Subject: Lodi Energy Center (08-AFC-10)
Data Response Set 1A, Responses to CEC Staff Data Requests 1 through 56

Data Request Set 1A
(Responses to Data Requests 1–56)

LODI ENERGY CENTER

Data Responses, Set 1A

FIGURE DR8-1A
AERIAL PHOTOGRAPH OF NATRUAL
GAS PIPELINE
 LODI ENERGY CENTER
 LODI, CALIFORNIA

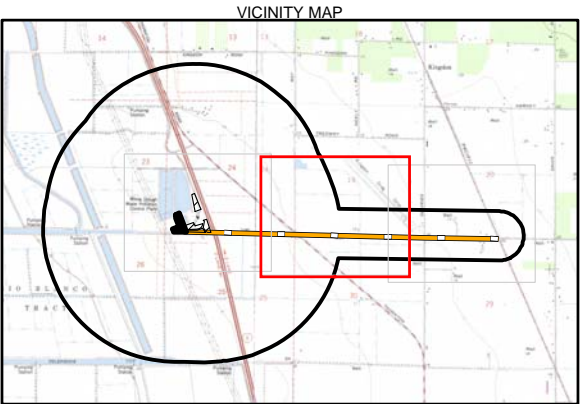
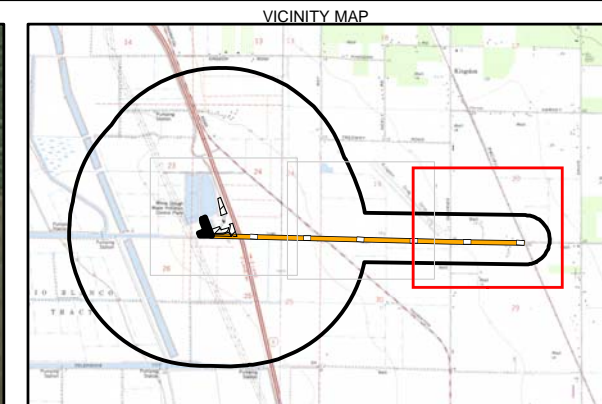
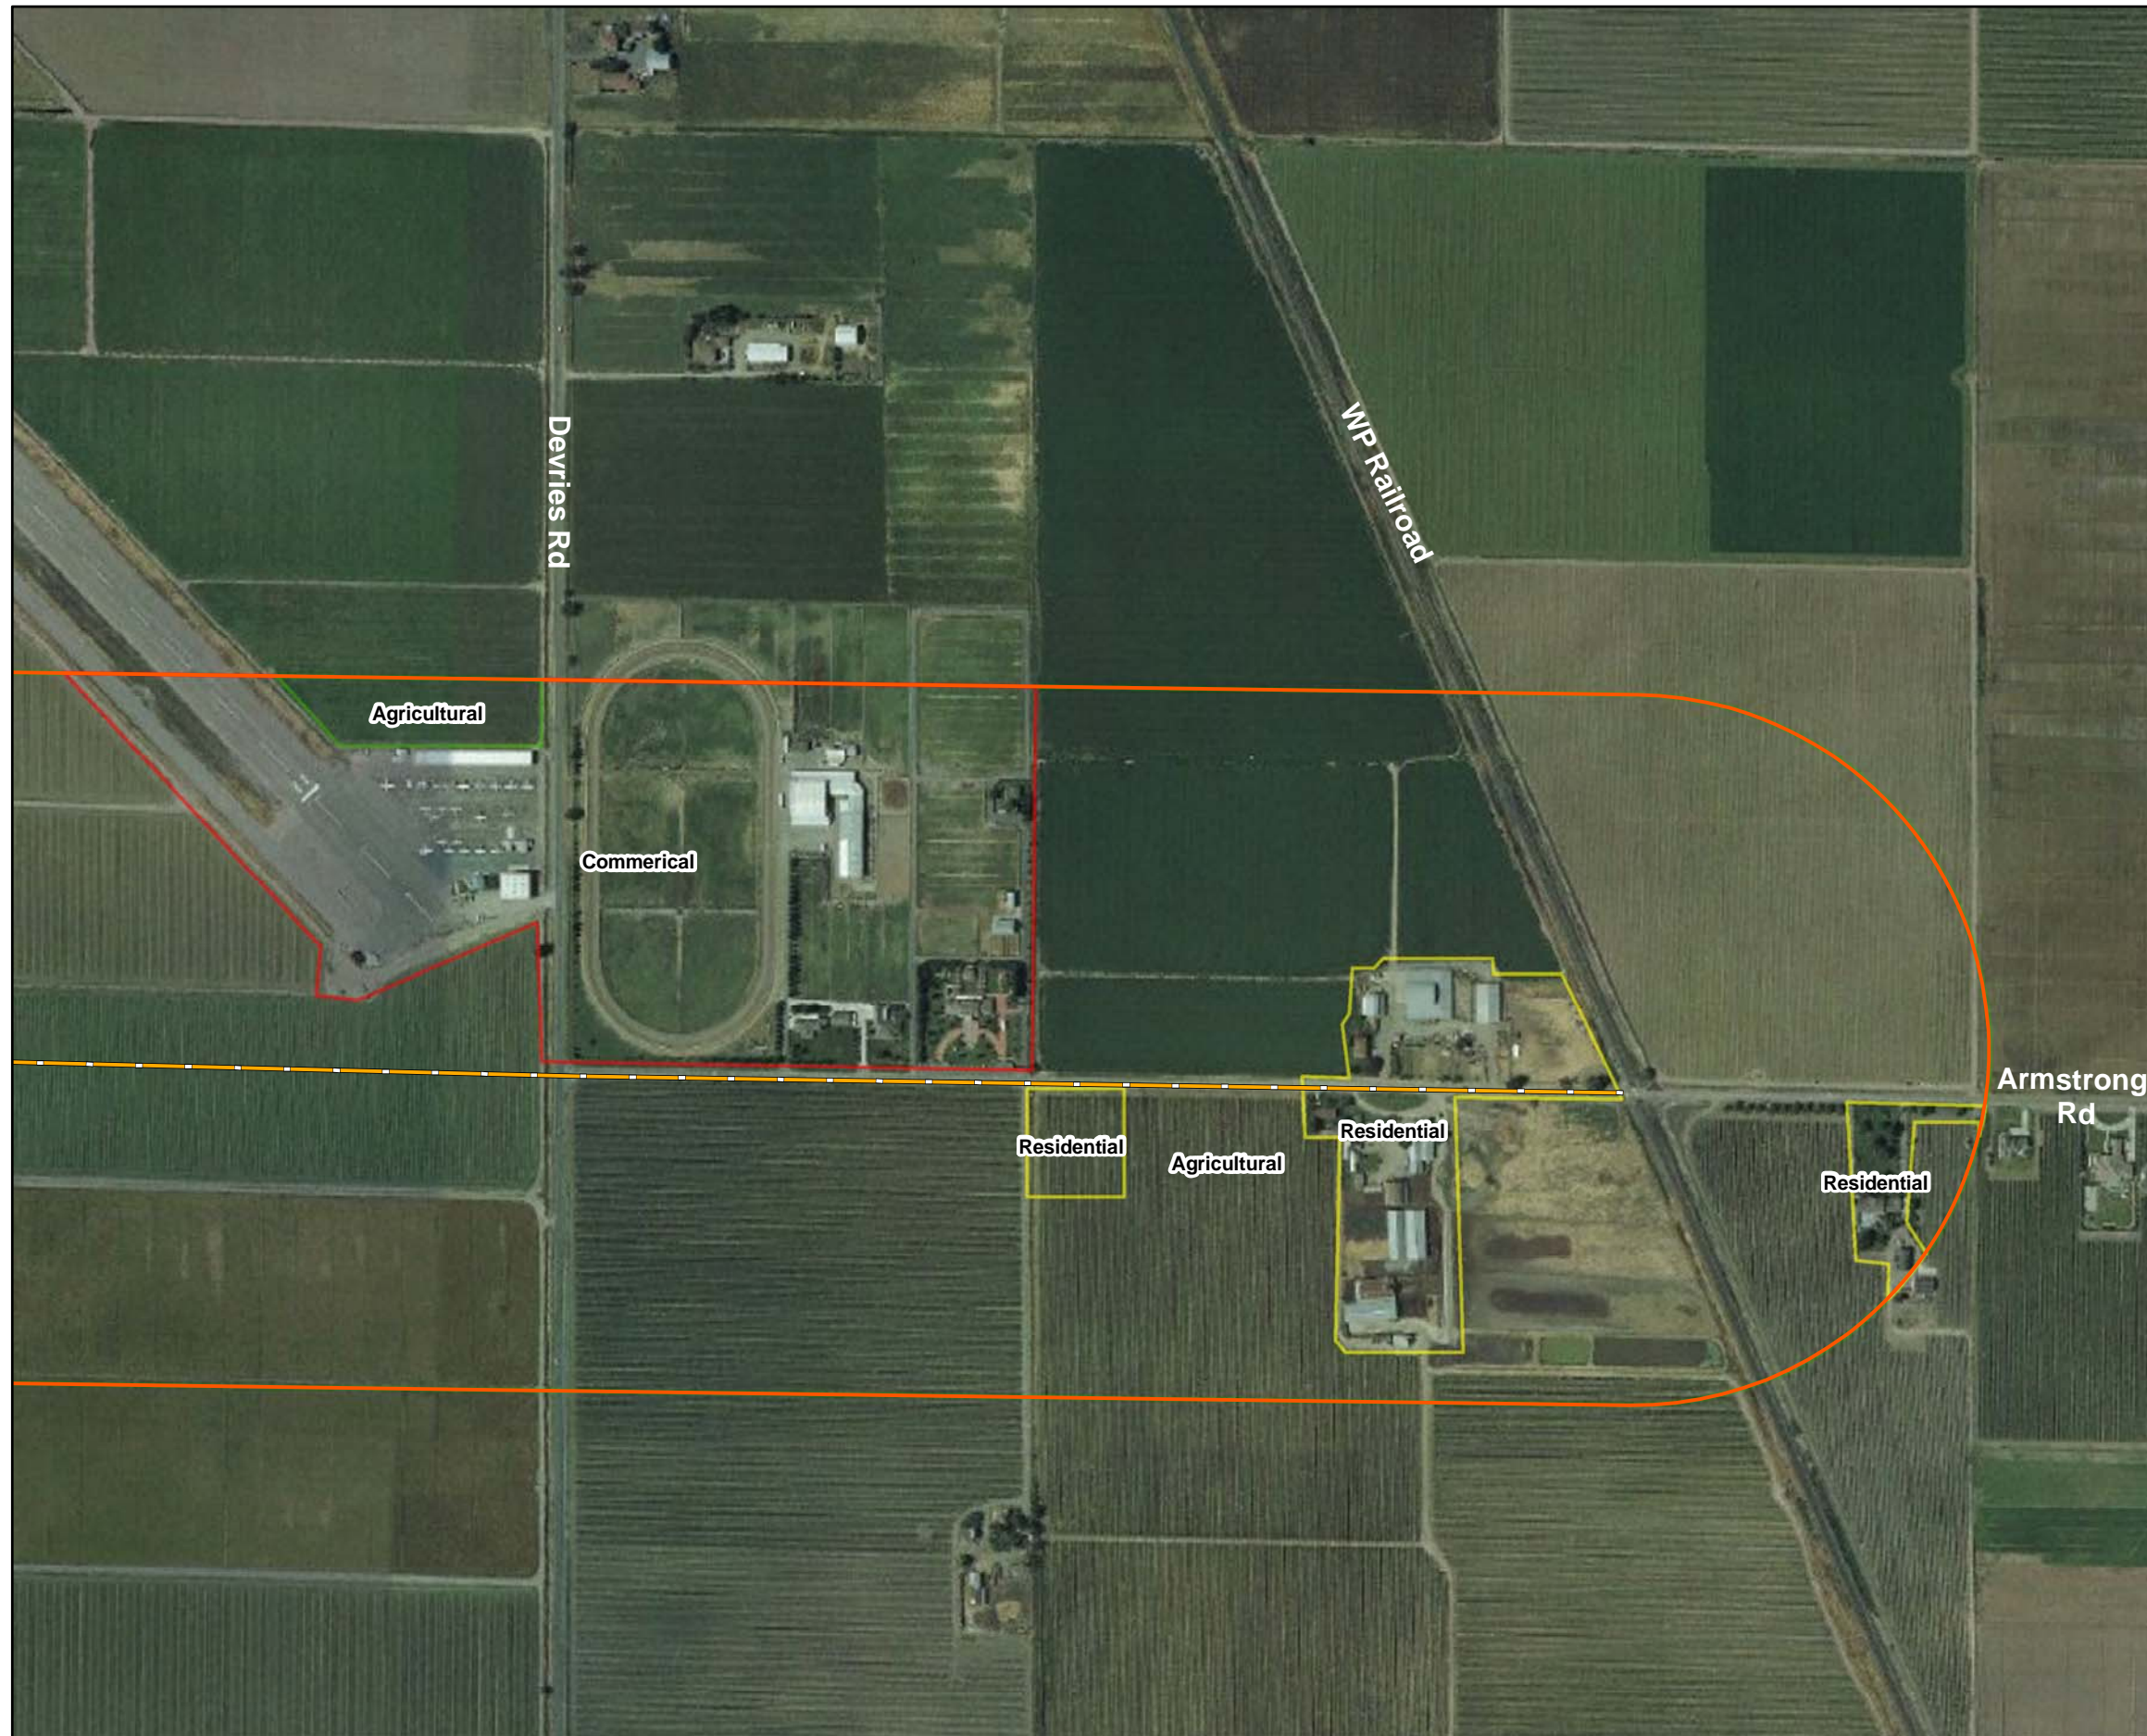
8. Please provide color aerial photographs taken at a recommended scale of 1 inch equals 500 feet (1:6,000) with a 30 percent overlap showing the proposed natural gas pipeline corridor so that the features pictured on the aerial photographs are not obscured.

Response: Figures DR8-1a through DR8-1c are provided at the recommended scale of 1:6000.

FIGURE DR11-1
ESTIMATED DEPTHS TO EXCAVATION
FOR PROJECT EQUIPMENT
LODI ENERGY CENTER
LODI, CALIFORNIA

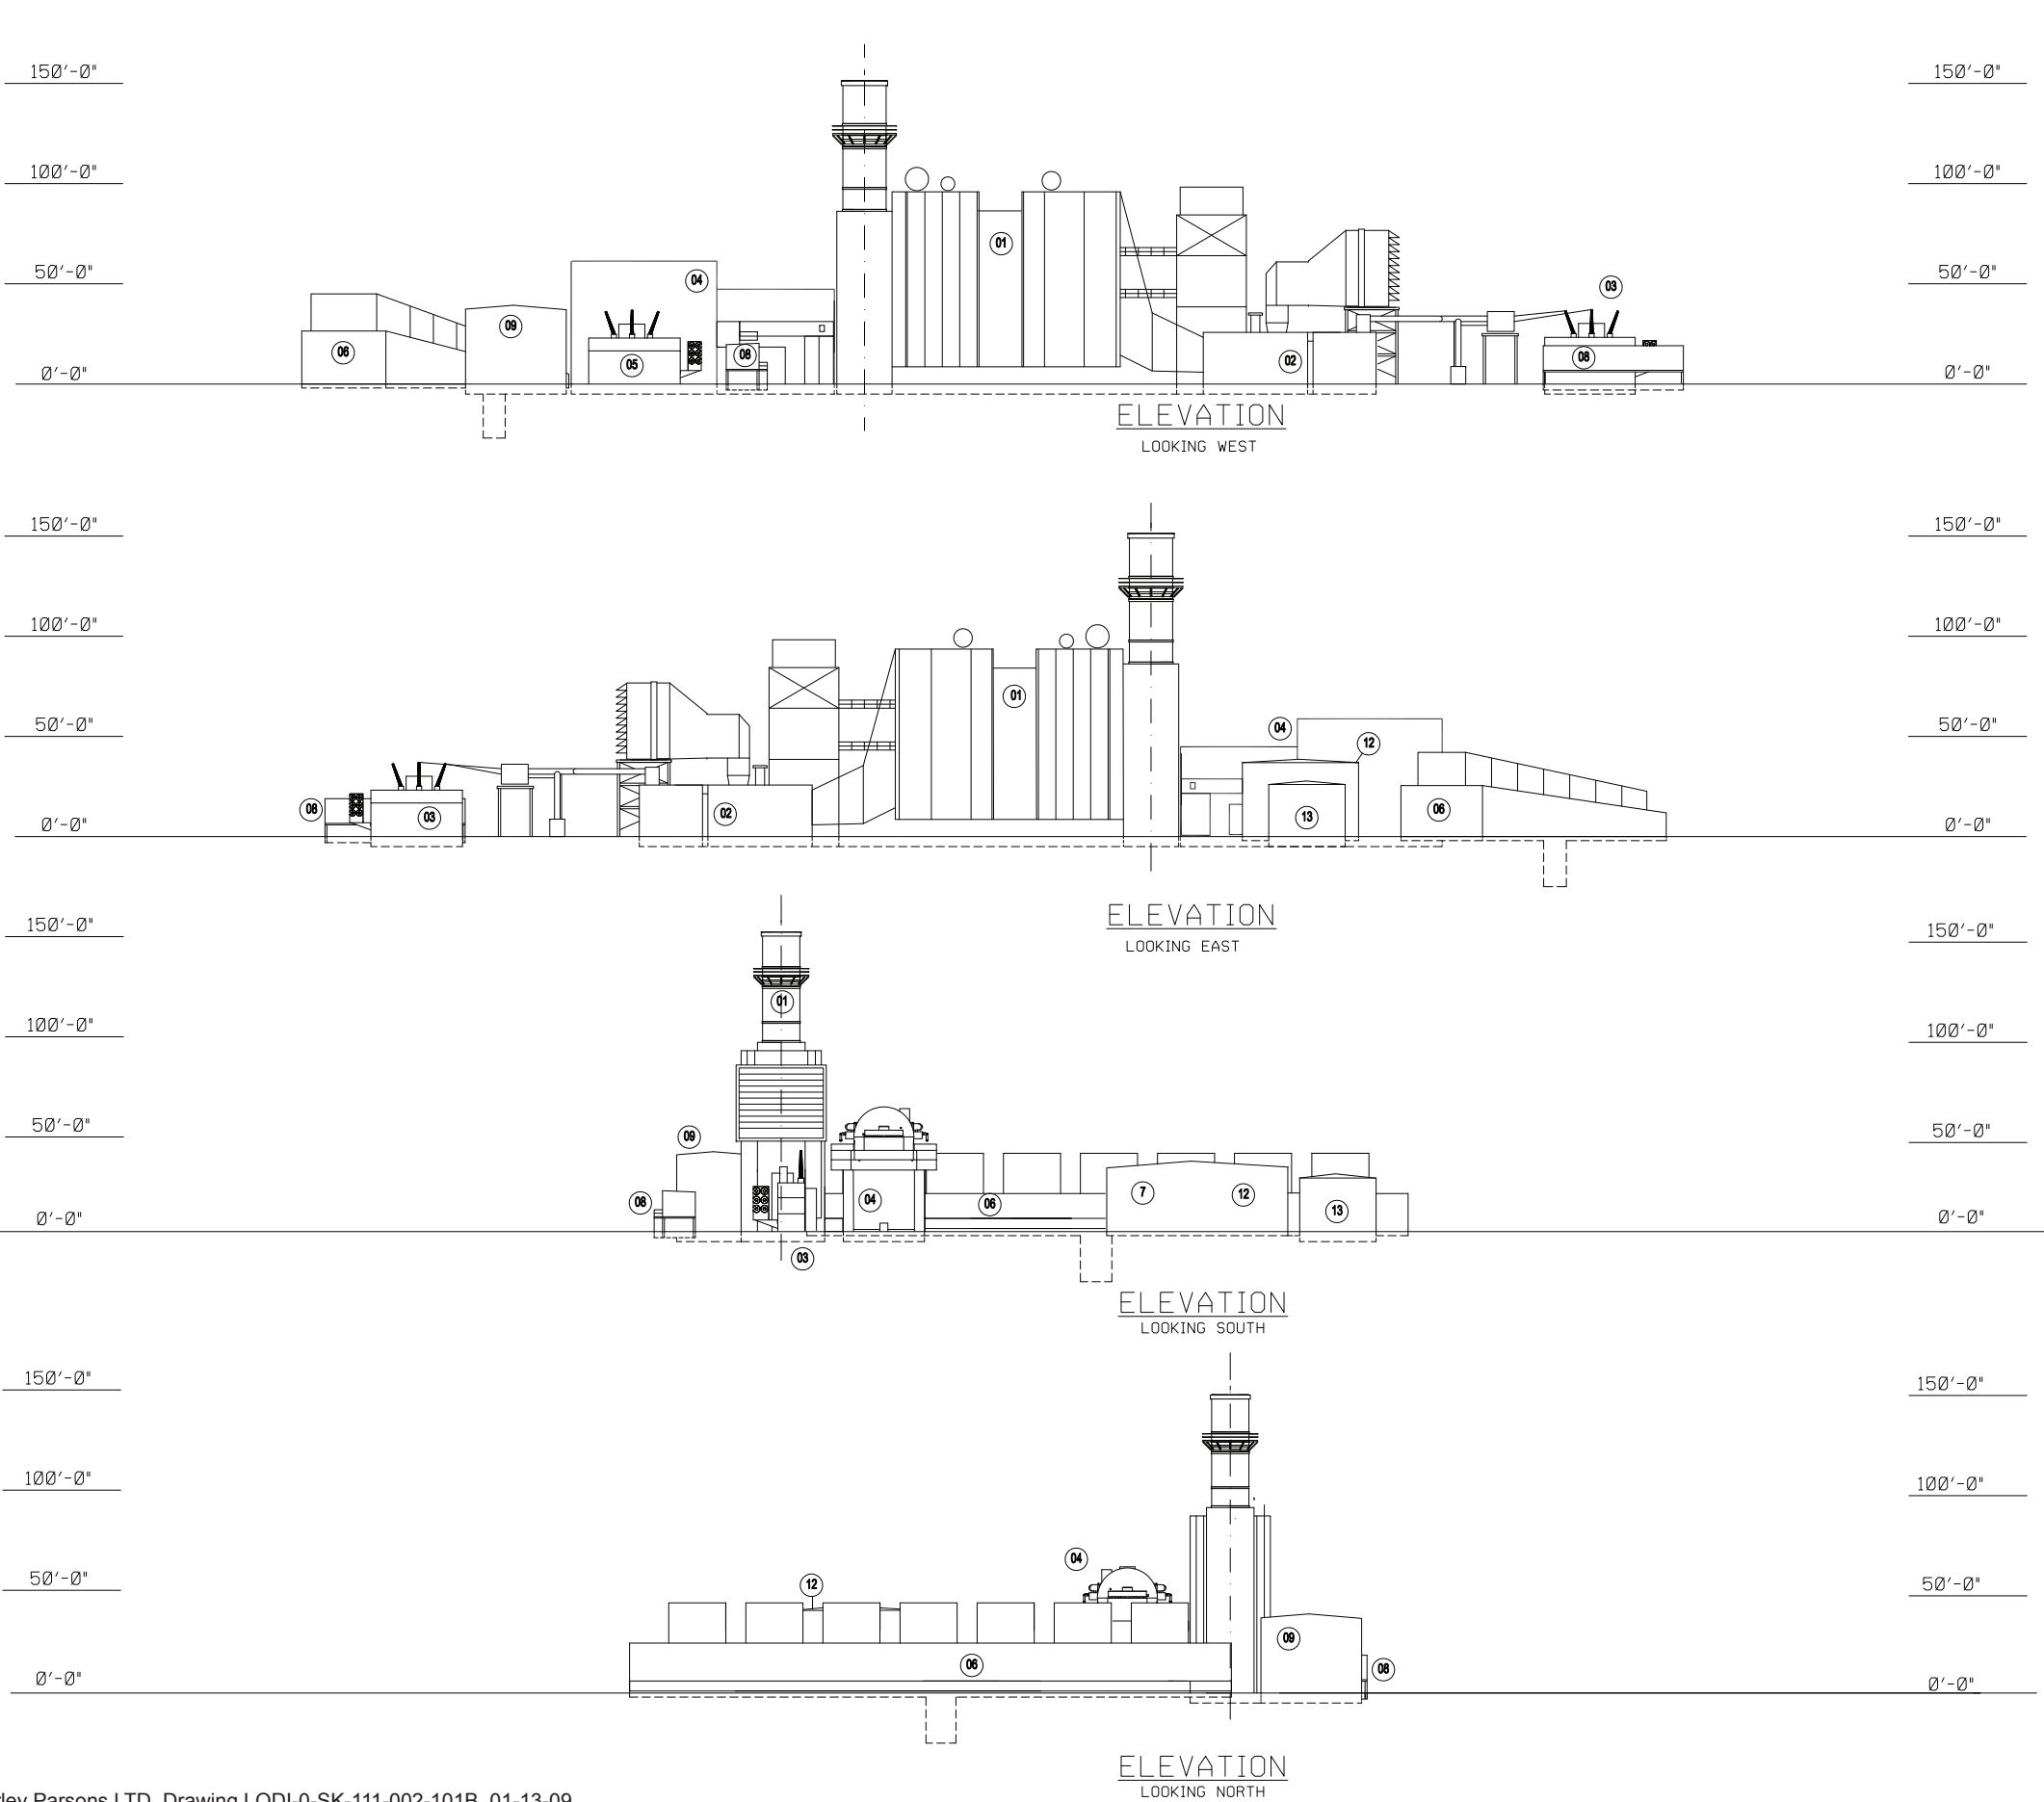
11. Please adapt Figure 2.1-2 (Proposed LEC Project Elevations) to show the expected depths of foundations for the illustrated equipment, pipelines, and underground tank installations.

Response: Figure DR11-1 shows the expected depths of foundations for the equipment, pipelines, and underground tank installations.

FIGURE DR12-1
PREVIOUSLY DISTURBED AREAS
AT THE LEC PROJECT SITE
 LODI ENERGY CENTER
 LODI, CALIFORNIA

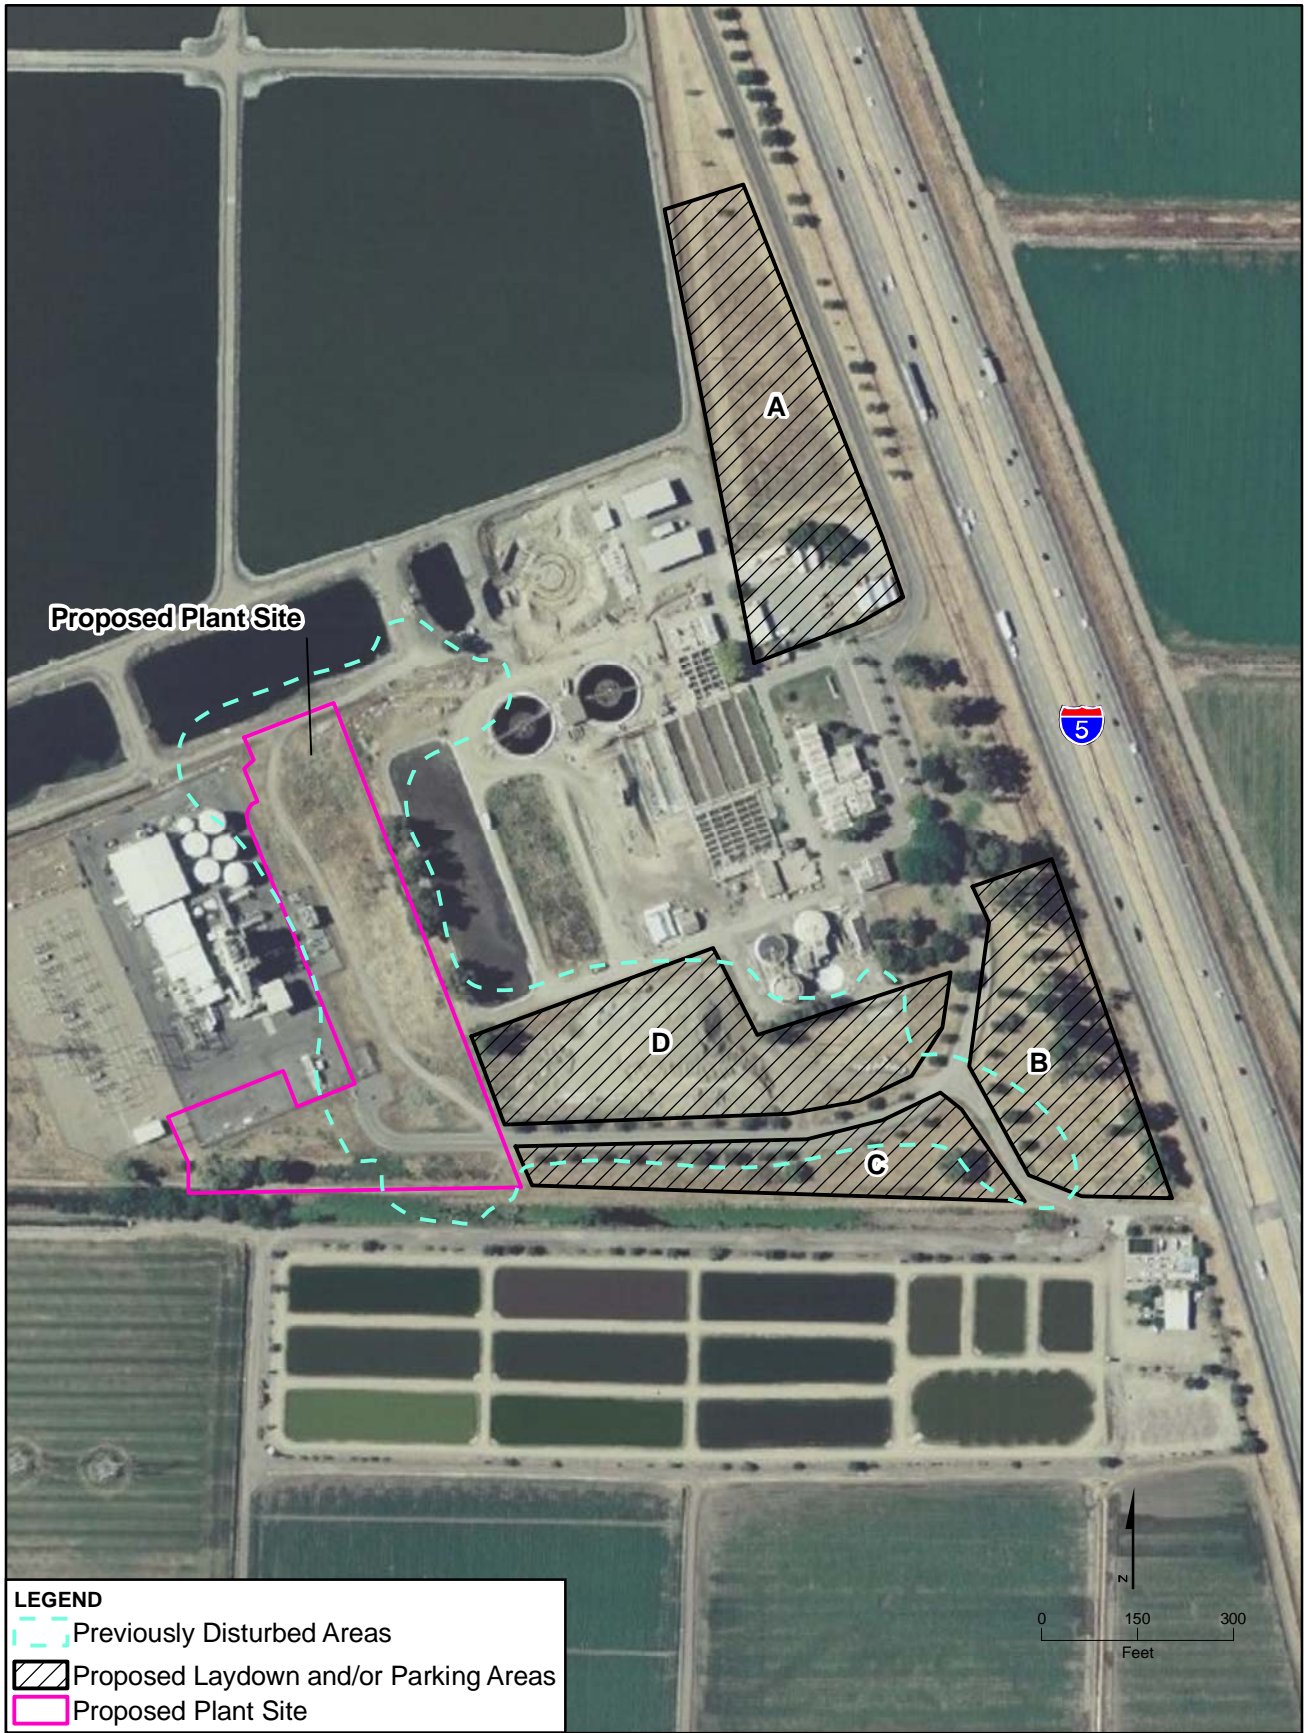
12. Please provide a separate project site plan showing the locations of all previous ground-disturbing activities. A site plan such as AFC Figure 2.1-3 with the disturbed areas indicated by shading or other such convention would be acceptable.

Response: Figure DR12-1 shows the locations of all previous ground-disturbing activities at the project site.
